# A1 in Northumberland: Morpeth to Ellingham

## **7.17.4 Applicant's Written Summary of Oral Submissions at Hearings - Appendix D - Warreners Private Means of Access**

**Appendix D - Warreners Private Means of Access**

**Figure 1 - Proposed Works**

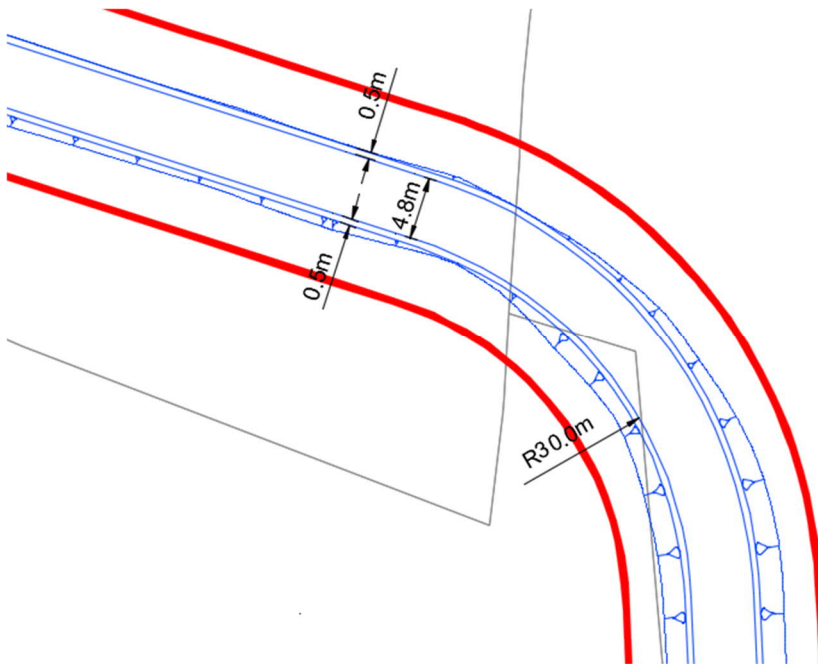
- 1.1.1. This document is submitted by the Applicant in queries raised by Mr Mark Hawes and the Examining Authority at the Compulsory Acquisition hearing held on 24 February 2021. In particular, it addresses the options considered and reasoning for the access road to plot 1/8b.

- Plot 1/8a: Construction of the tie-in of the new PMA approach with the existing access to Northgate Farm.
- 2.1.3. The PMA has a proposed width of 4.8m with 0.5m verges and a turning radius of 30m, as shown in Figure 1. The vertical alignment of the PMA closely follows the existing terrain to avoid large earthworks. The PMA can accommodate a combined harvester and trailer. Further, the design complies with the *Residential roads and footpaths in Northumberland* manual.
